SERVICE BULLETIN #153

Serviceability Improvements on Popular Webb Steer Axle Brake Drums

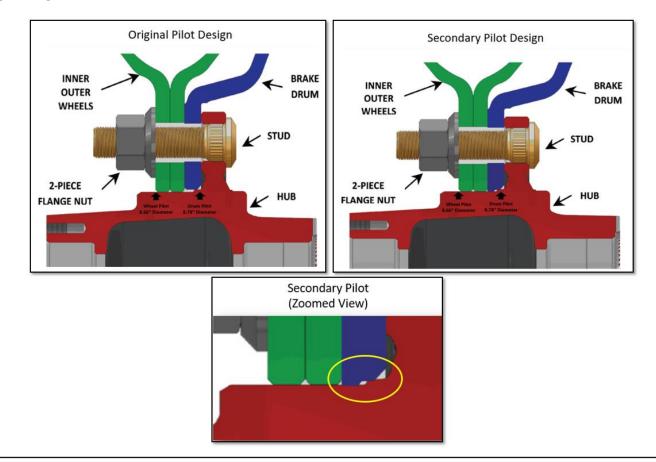
To improve upon the serviceability of popular steer axle brake drums offered by Webb Wheel Products, a secondary pilot has been designed into the mounting flange. This pilot improves the brake drum's ability to properly align with its mating hub and reduce the potential of a mis-installation and its subsequent effects. The brake drum mounting interface conforms with SAE J1671 by maintaining a primary mounting pilot of ~8.78" and a mounting chamfer of ~0.12". The secondary pilot will maintain a diameter of ~8.66" which will slightly engage the hub's wheel pilot and help reduce the potential of the brake drum's disengagement from the hub's drum pilot during the installation process. Effective immediately, the secondary pilot will be machined into the following Webb brake drums: **61528B**, **65548B**, **65710B**, **65151B**. When installing all Webb brake drums, always refer to the procedures outlined in TMC RP 662 "Outboard Drum Removal And Installation Procedures for Class 7-8 Wheel-Ends" or click here to visit Webb's Online Training Toolbox.
